HISTORIC AND DESIGN REVIEW COMMISSION

August 21, 2019

HDRC CASE NO: 2019-450
ADDRESS: 110 LEXINGTON
LEGAL DESCRIPTION: NCB: 804 BLK: 32 LOT: W IRR 69.22' OF A9 & W IRR 96.14' OF A10
ZONING: FBZ T6-2, H, RIO
CITY COUNCIL DIST.: 1
APPLICANT: Ian McClure/Phoenix Hospitality Group
OWNER: Edward McClure/EL TROPICANO HOTEL LLC
TYPE OF WORK: Exterior modifications, rehabilitation, partial demolition, and demolition of the existing parking garage
APPLICATION RECEIVED: August 02, 2019
60-DAY REVIEW: October 01, 2109
CASE MANAGER: Edward Hall
REQUEST:

The applicant is requesting a Certificate of Appropriateness for approval to:

EXTERIOR ELEVATIONS PROPOSED WEST ELEVATION

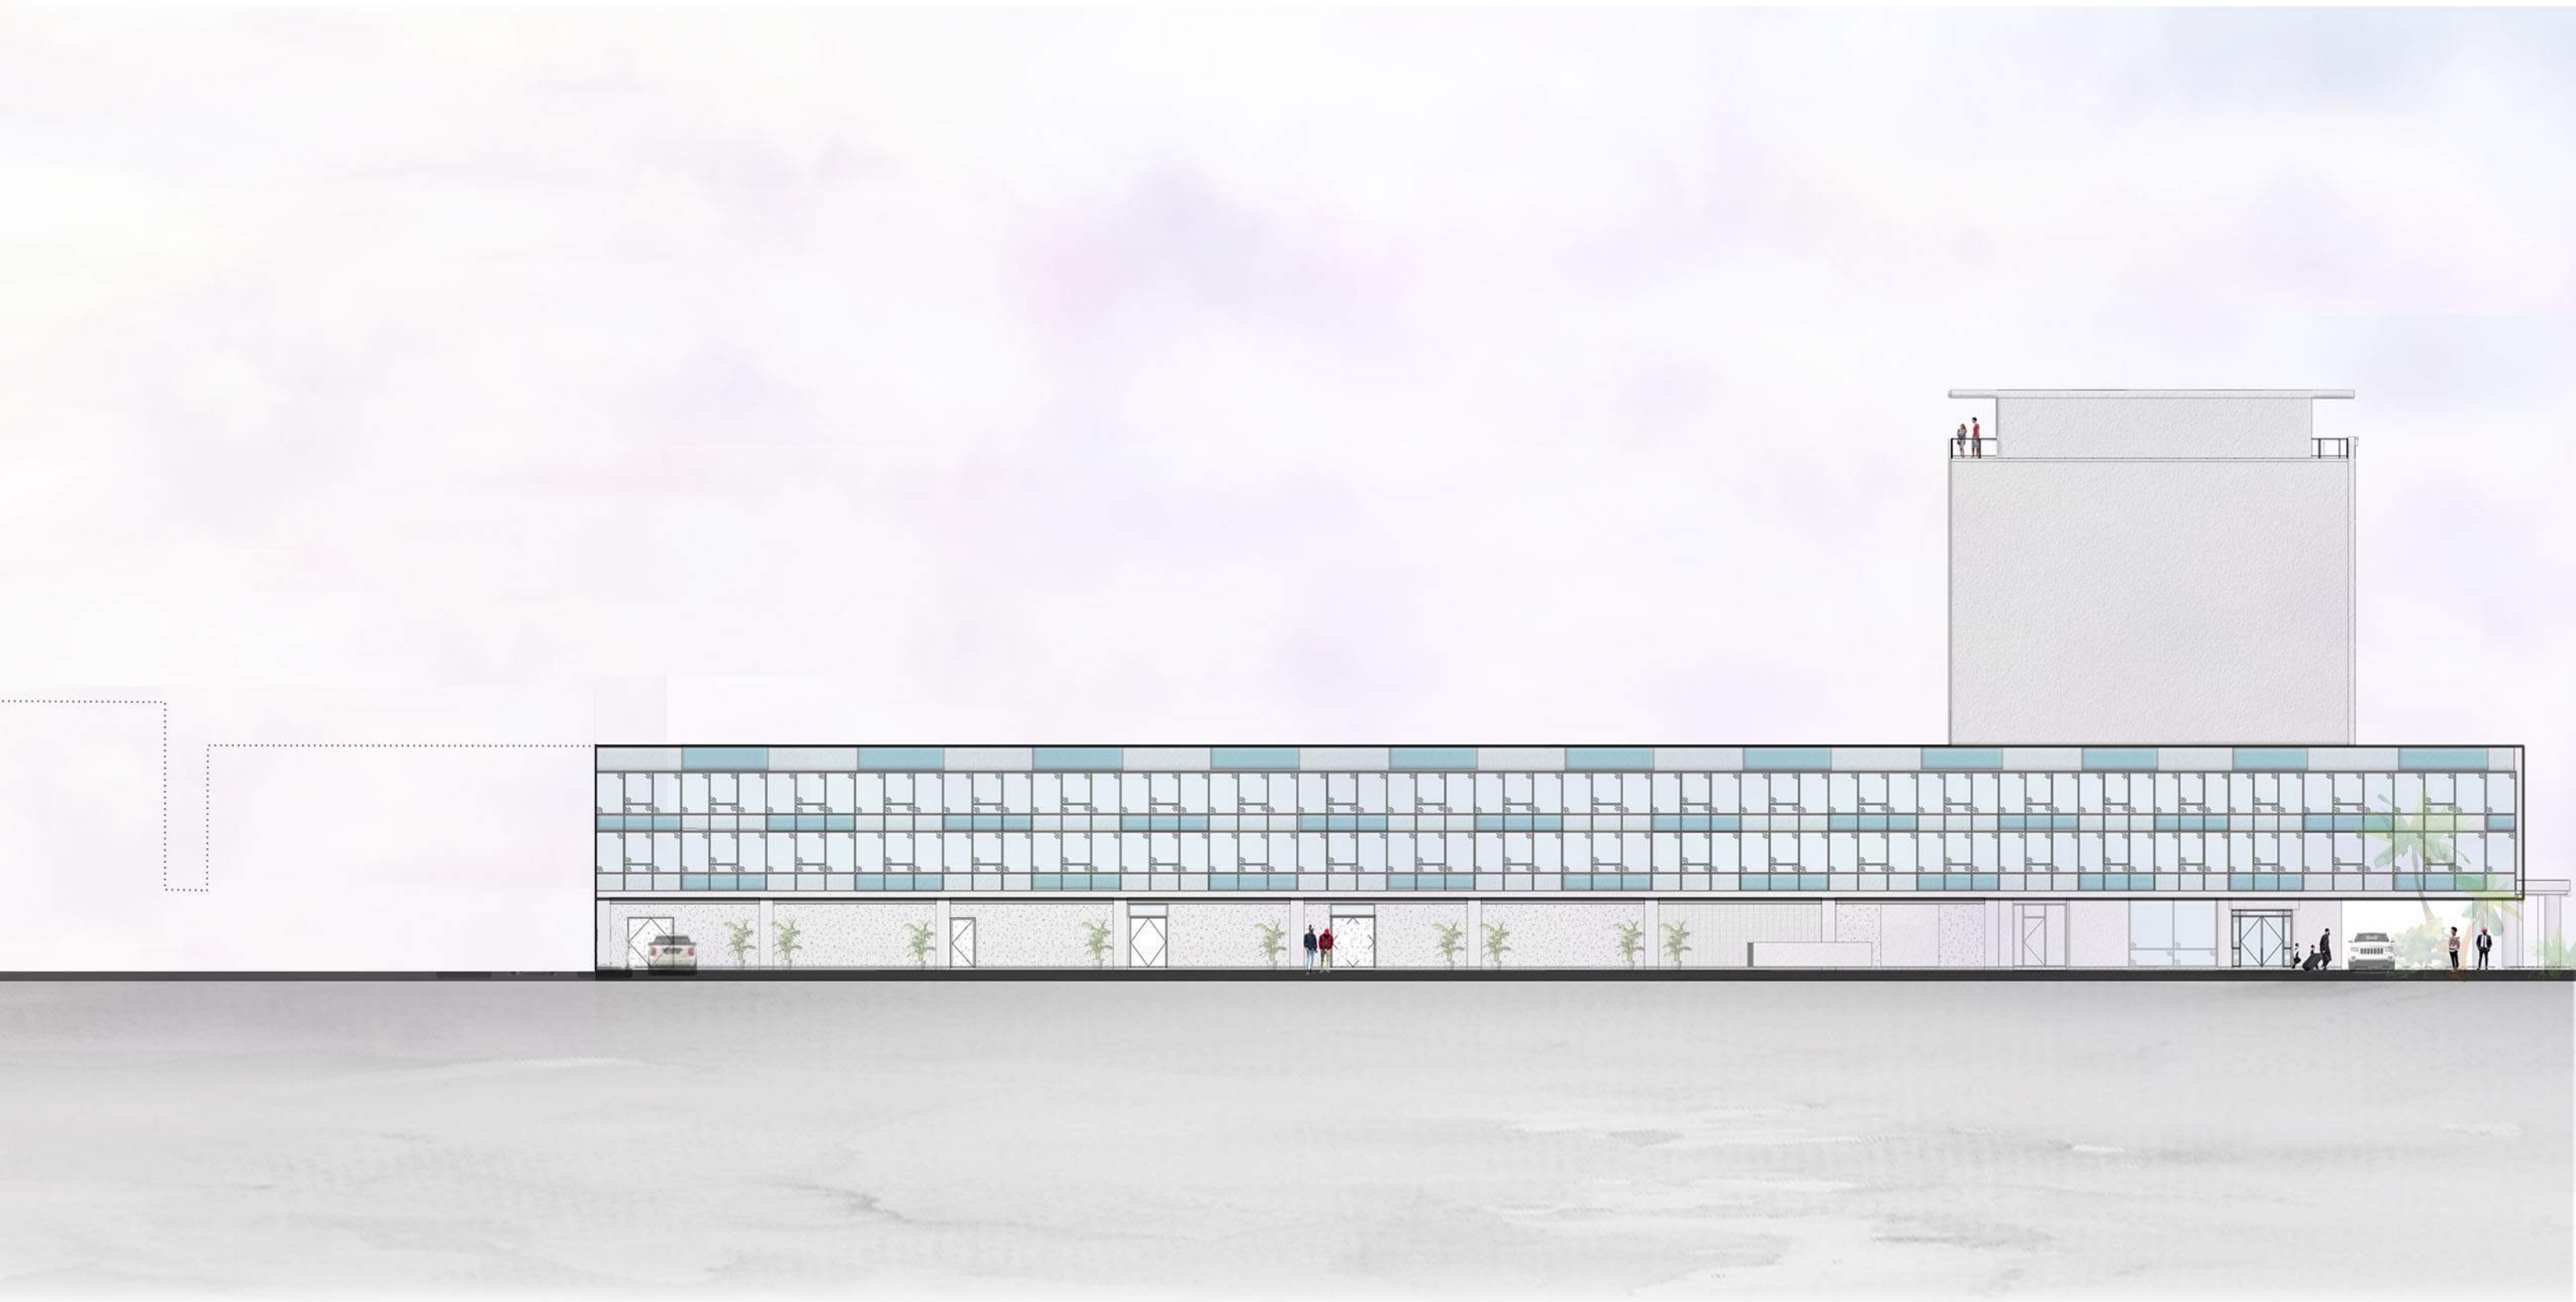
- c. STUCCO PILASTER & BANDING REMOVAL – The applicant has proposed to remove the stucco pilasters and banding on the west façade in their entirety on the entire height of the structure. The Guidelines for Exterior Maintenance and Alterations notes that non-historic facades should be returned to their original design based on photographic evidence. Per historic photos of the hotel, these elements did not originally exist. The applicant has noted that the original glazing system will be restored, which staff finds to be appropriate and consistent with the Guidelines.

- d. STOREFRONT PANEL REMOVAL (Southwest corner) – The applicant has proposed to remove the existing storefront panels at the southwest corner of the first floor to create an entry for a future retail space and install new a new storefront system and panels to match the existing in profile and finish. The applicant has proposed to modify a small portion of this existing storefront system, and install a new entry to match the existing, which staff finds that be

- f. ENTRY DOOR REPLACEMENT (West façade) – The applicant has proposed to the existing sliding entry door with a new storefront system to match the existing in profile and finish. This modification will be to the immediate left (north) of the new entrance proposed in finding c. Staff finds this replacement to be appropriate, as the profile, materials finish will match the existing.

EXTERIOR ELEVATIONS PROPOSED SOUTH ELEVATION

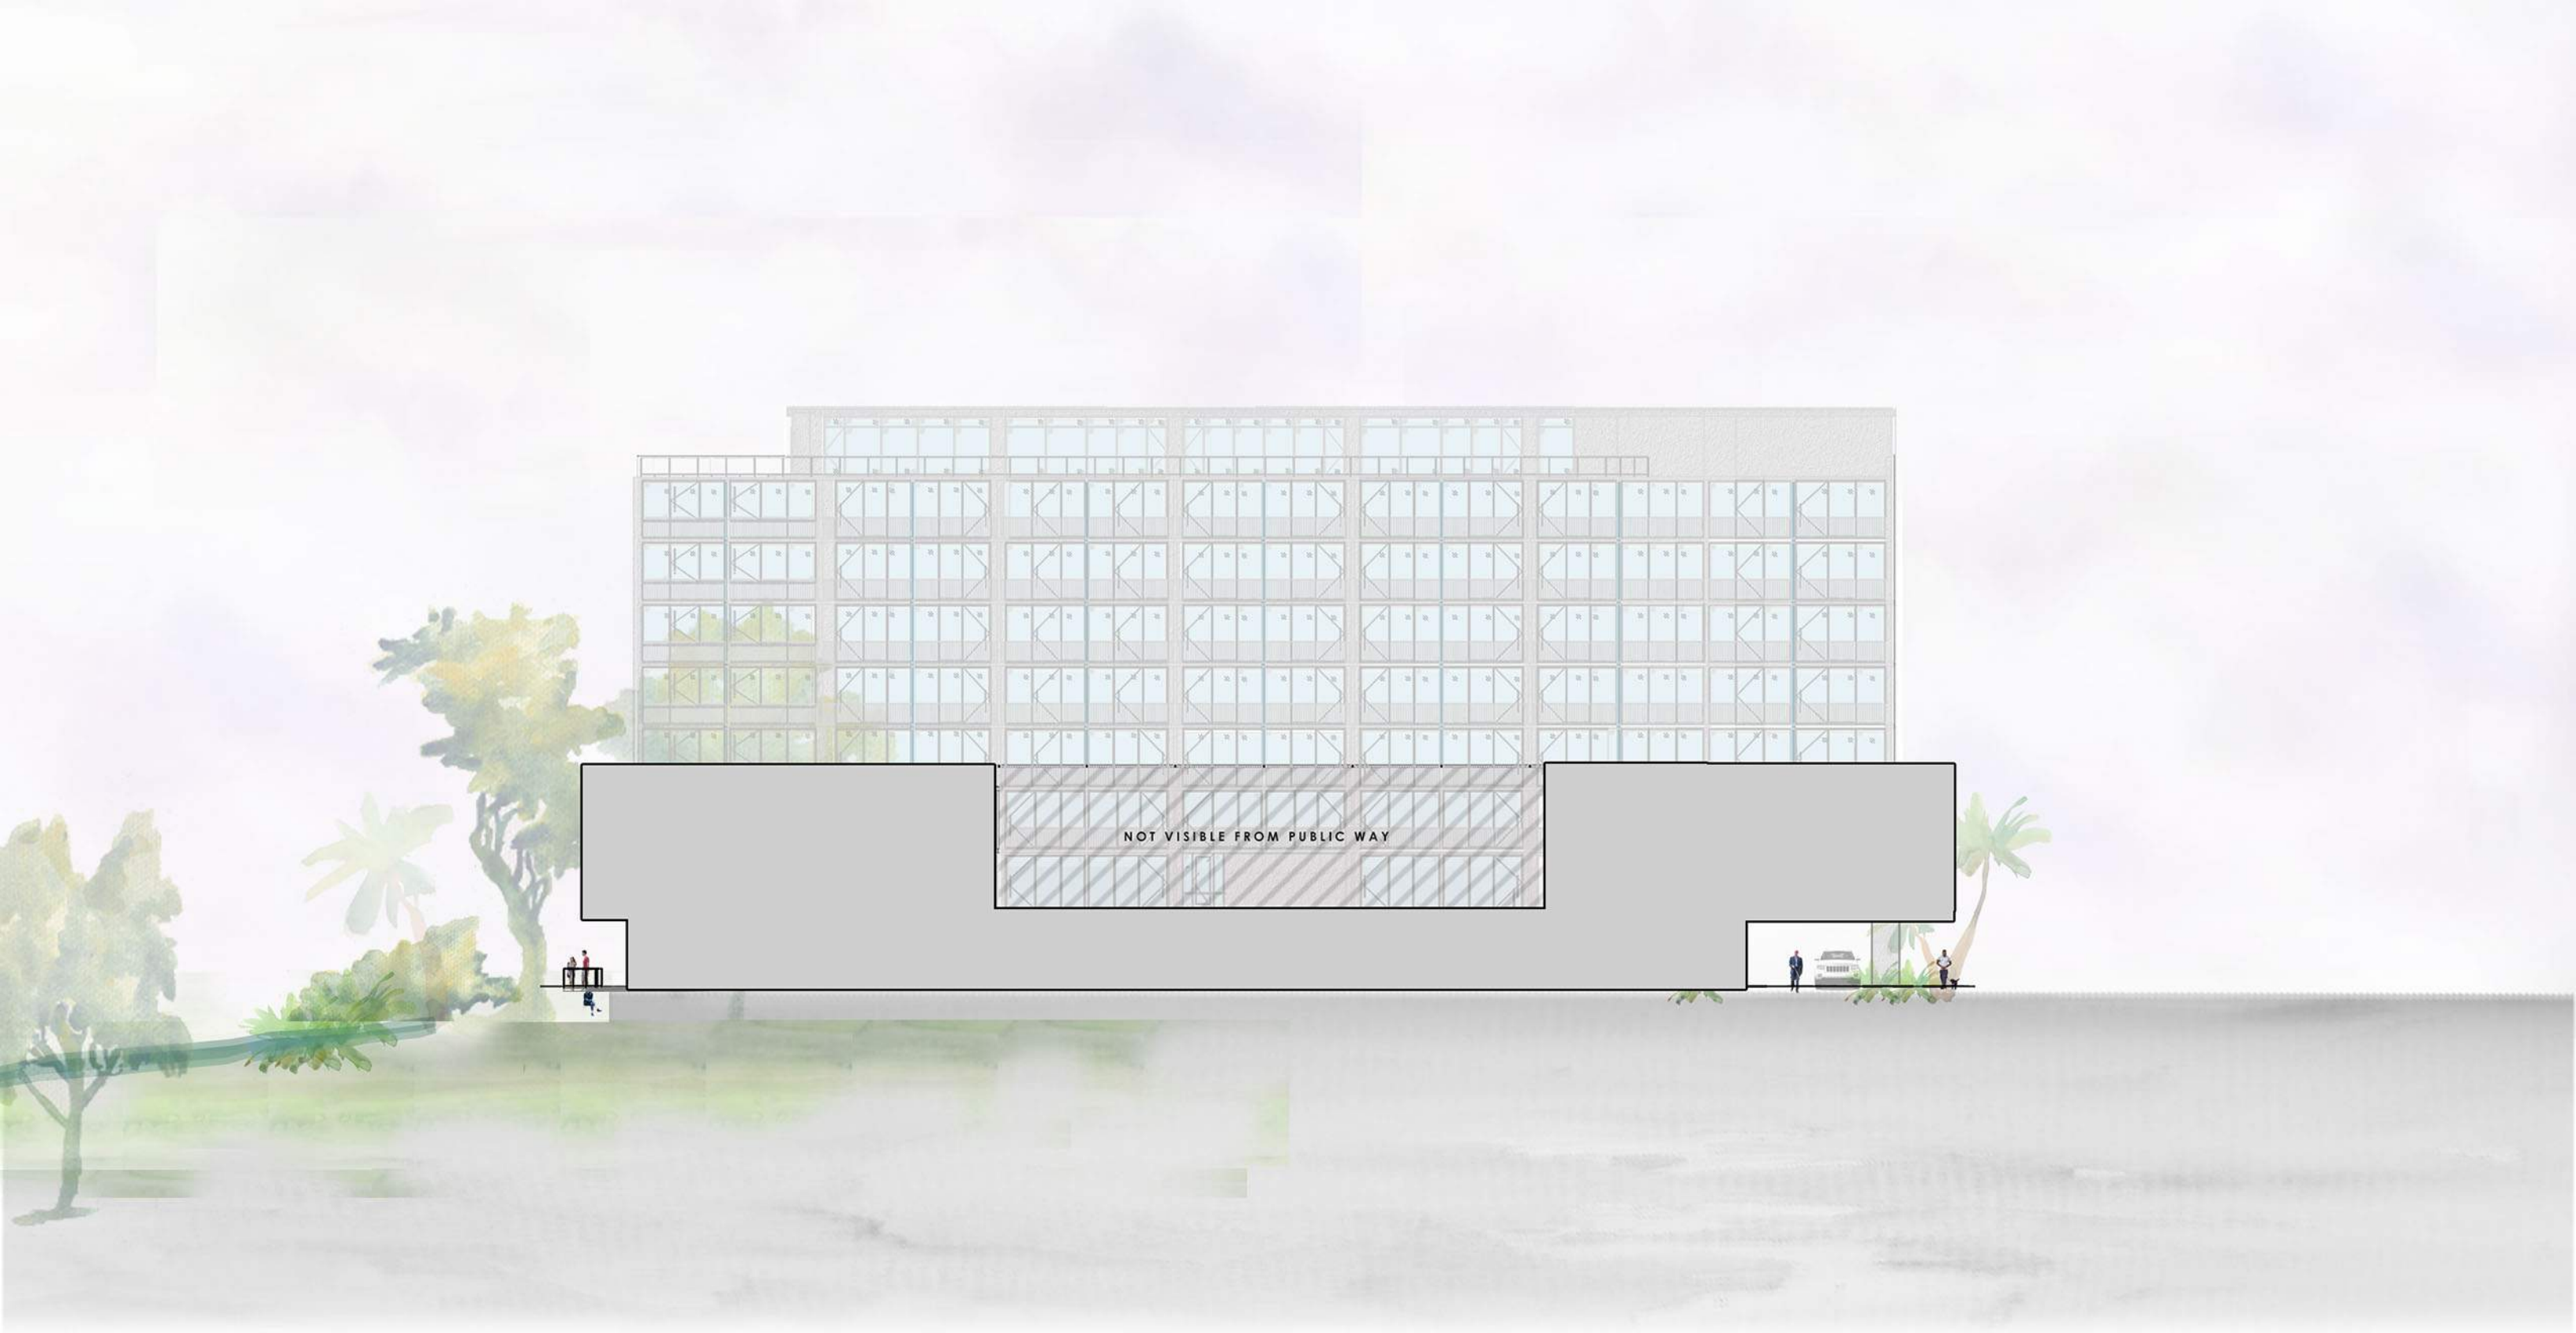
- i. STOREFRONT SYSTEM REPLACEMENT (South facade) – The applicant has proposed to replace the existing, non-original storefront system on the south façade with a new storefront system that is to match the original in profile, finish and spacing. Staff finds this to be appropriate and consistent with the Guidelines.

- k. STAIR REMOVAL AND STOREFRONT ADDITION (South façade)– The applicant has proposed to remove the existing, non-original stair connecting levels one and two, infill the floor on level two, and add a storefront system to match the profile of the existing. Generally, staff finds the proposed modifications to be appropriate, as this stair and void in the façade were not original to the structure.

PROPOSED SCOPE - WEST ELEVATION

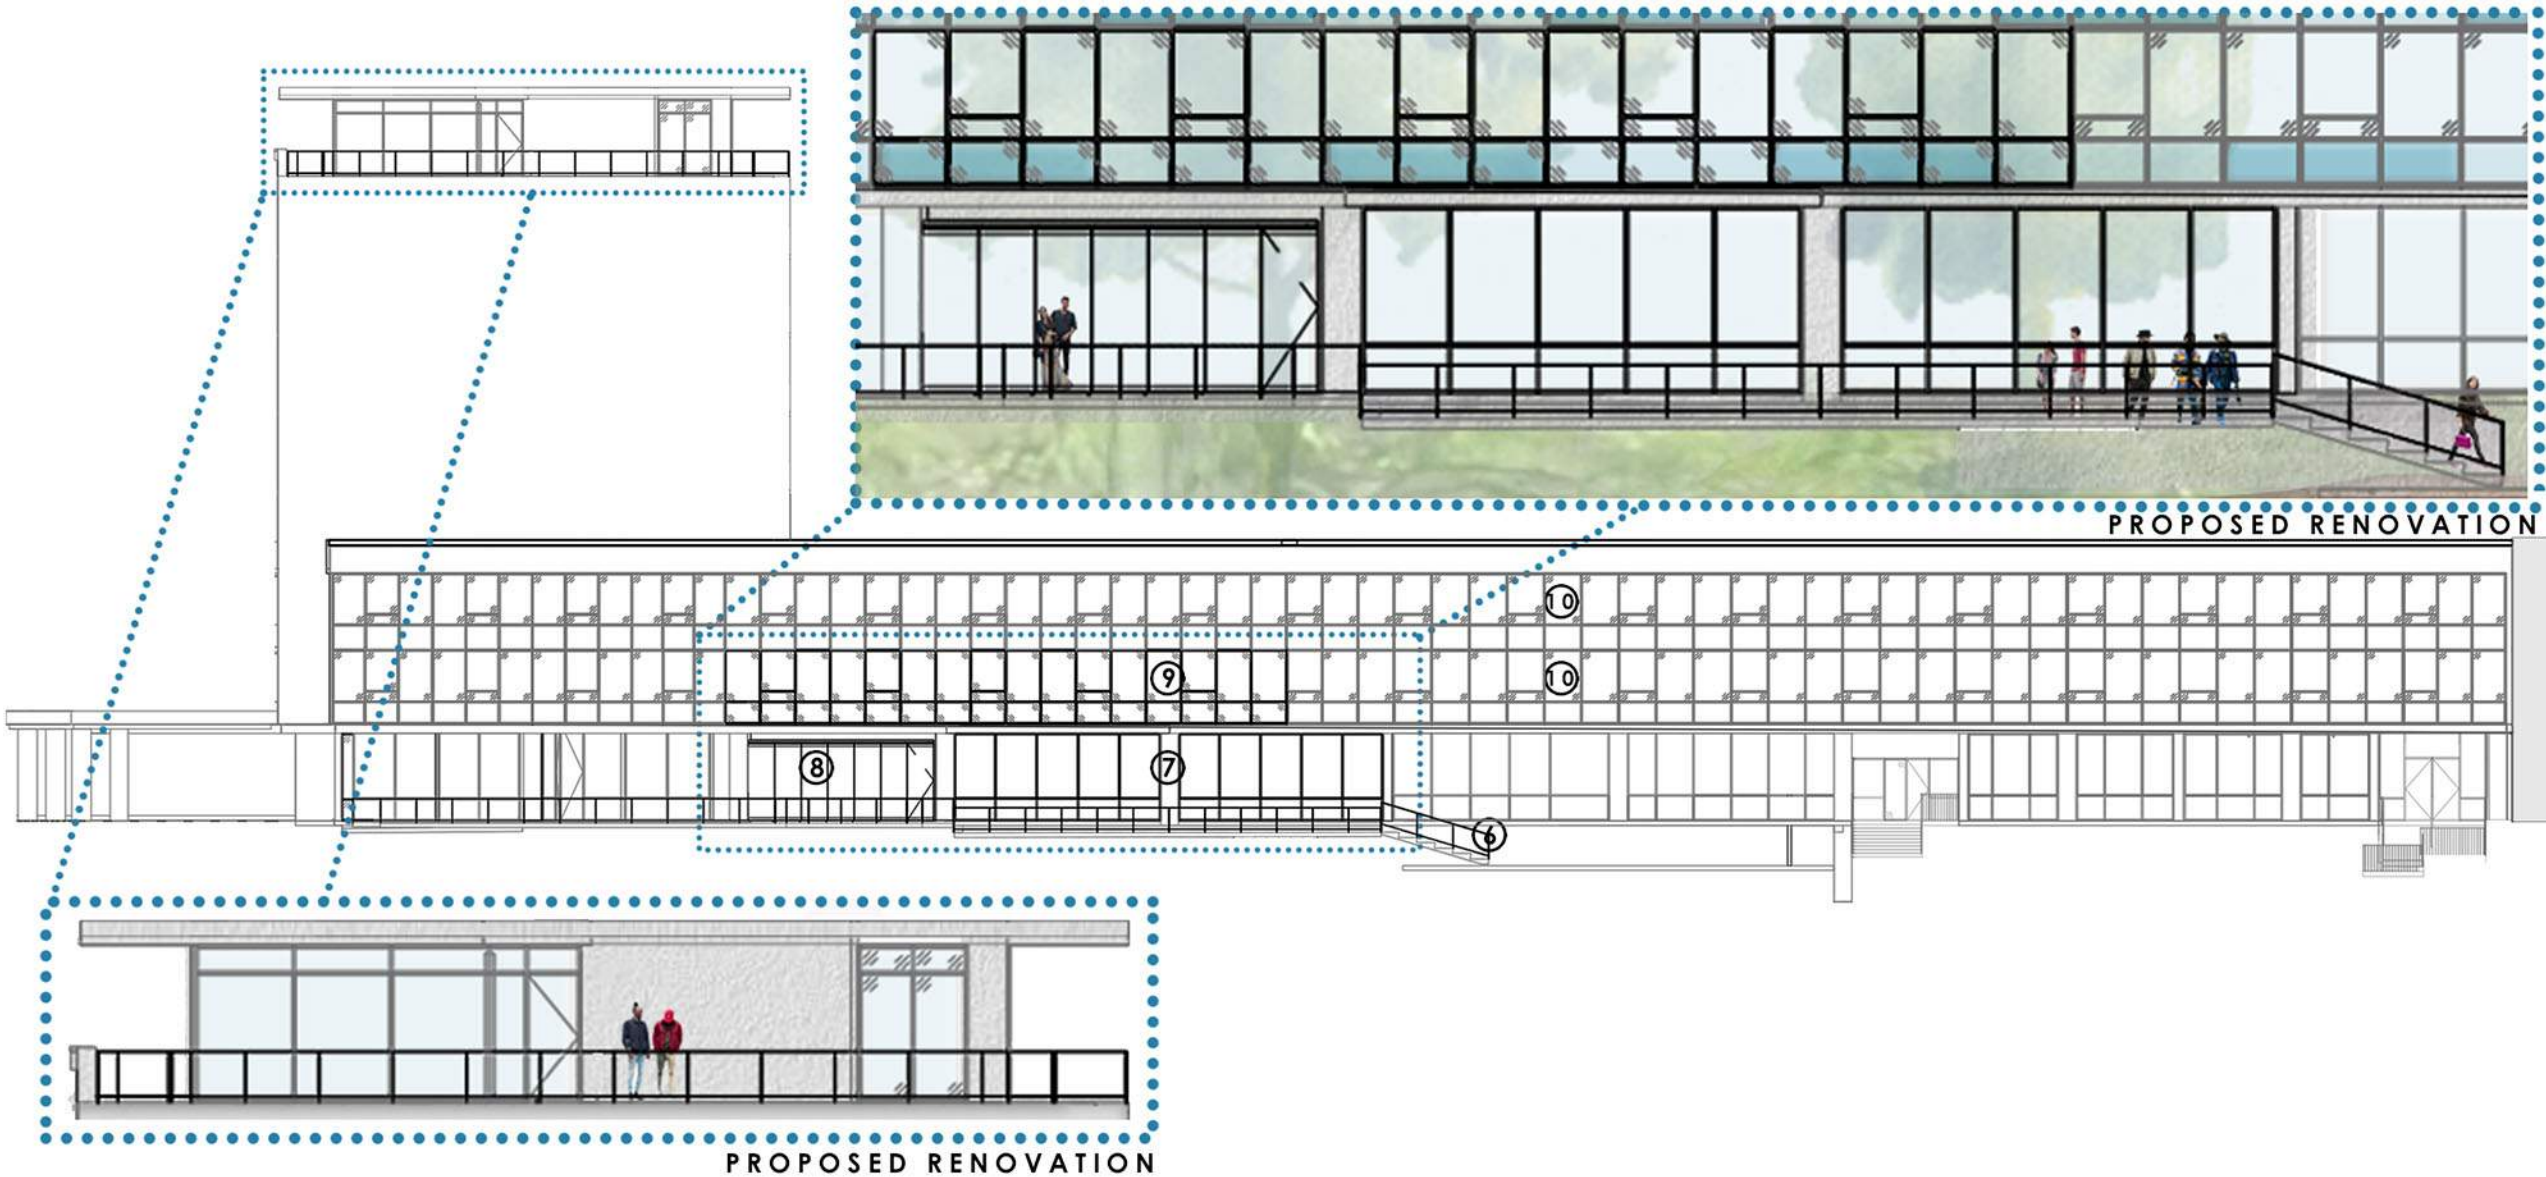
- e. STONE VENEER REMOVAL – The applicant has proposed to remove the existing stone veneer throughout the street level façade and replace it with fine-textured stucco. Historic photos note what appears to be stone at the first floor exterior. Per the Guidelines, character defining features should be preserved. Staff does not find the removal of the existing stone veneer to be appropriate and finds that it should remain as is to be consistent with the Guidelines.

- h. GUARDRAIL REPLACEMENT – The applicant has proposed to replace existing, metal guardrails with glass guardrails. Historic photos note guardrails that differ from those currently on site. While not a return to those found historically on site, staff finds the proposed glass guardrails to be minimal in profile and appropriate.

Staff does not recommend approval of item #3, the removal of the existing stone veneer and installation of fine textured stucco based on finding e. Staff recommends that the applicant maintain the existing stone.

Staff does not recommend approval of item #5, the replacement of the existing soffit with a wood soffit based on finding g. Staff recommends that the soffit be repaired in-kind.
